Question from Committee, Sep. 16

September 16, 2020

Figure 1: Evacuated glass tube support structure and description

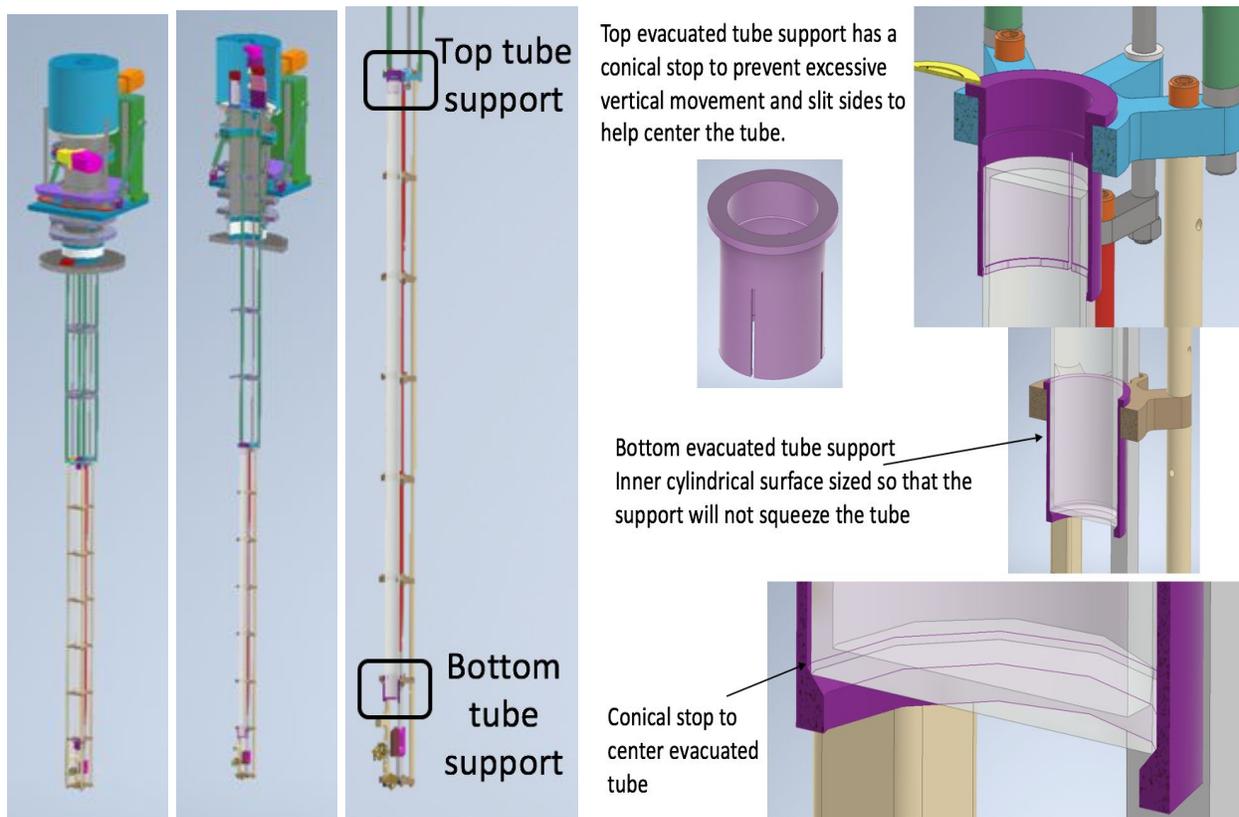
2) What engineering analysis is envisaged going forwards to ensure that the evacuated tube can withstand all of the different cryogenic conditions during cool-down?

The MicroBooNE laser periscope demonstrates that the concept is reasonable as the same tube has been used in MicroBooNE. Additionally in our case, it actually has less stress as it is not held at the flange. We plan to fabricate a lower periscope assembly which will include the evacuated tube. This assembly will be thoroughly tested in a cryogenic environment at LANL.

As can be seen in the pictures below, the glass tube is very gently supported and it is allowed to move (about 0.5 mm or so). The Maroon object is the support structure present at the top and bottom of the tube and it is a conical stop that will help center the tube. The bottom support is designed such that it will shrink with temperature and doesn't squeeze the glass tube.

Figure 3: (Left) original concept, (middle) Candidate scheme to mitigate load on the break, (right) close up view of the candidate scheme

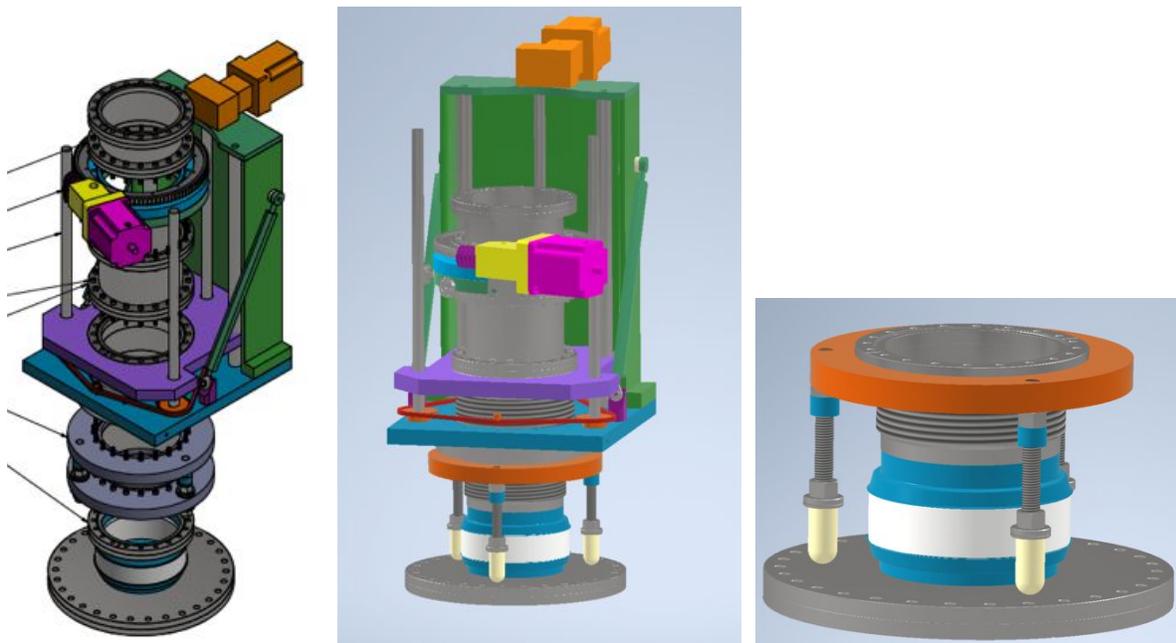
8) Considering that the ceramic insulation needs to support more than 130 kg with a long lever arm, what mechanical analysis has been performed to show that it has adequate strength?

This is a very good question and something we have been thinking about on how to address. Candidate Scheme to combine the functions of the vacuum break with the port aligner is shown in Figure 3 below. This approach results in the load path avoiding the ceramic break.

Figure 4: (left) camera and PMT assembly mechanical drawings (currently in the design). (right) candidate camera from Planetary Cameras with 1/1.8" CMOS IMX178 sensor and a resolution of 6.4 Mega Pixels 3096*2080

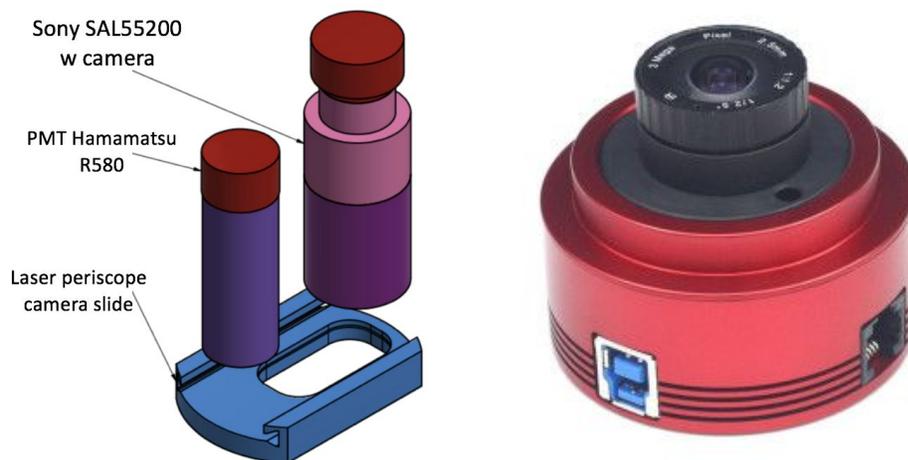
11) Are there documented details on the PMT / Camera system? They should be included in the system diagrams.

Glenn' [talk](#) on cameras at the May 20 CALCI scope review provides more details on the PMT/Camera system.

We have a drawing for the [camera and PMT assembly](#) on EDMS.

Vendor choices are still being finalized especially for the PMT. Our first order choices are shown in Figure 4.

For the PMT, the plan is to have a TPB-coated PMT that could see UV light in the bandpass of the periscope mirrors. We currently have Hamamatsu PMT R580 in the design but the exact details and requirements for this need to be flushed out.

For the camera, we are now considering the Astronomy imaging camera, [ASI178 MM/MC](#) high resolution imaging from Planetary cameras (\$349). These cameras are not very expensive, so we plan to buy a couple of candidate cameras and test them.

Once vendor choices are finalized, the designs will be updated and this change will be straightforward.
